## KINGSVILLE TOWNSHIP PAVING (Dibble Road Paving) KINGSVILLE, OHIO

## TO PROSPECTIVE BIDDERS <u>MARCH 19, 2025</u> <u>ADDENDUM NO. 2</u>

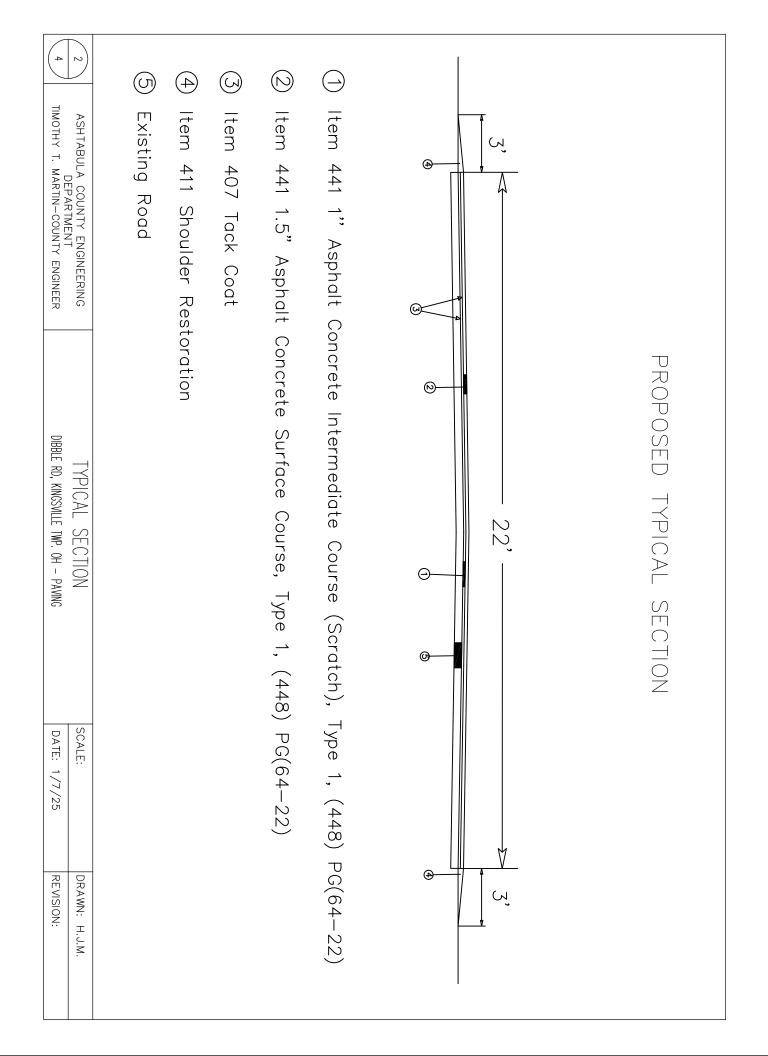
The Shoulder Restoration material shall be Item 411. Replace Sheet 2 and 3 in the plan set with the attached sheets.
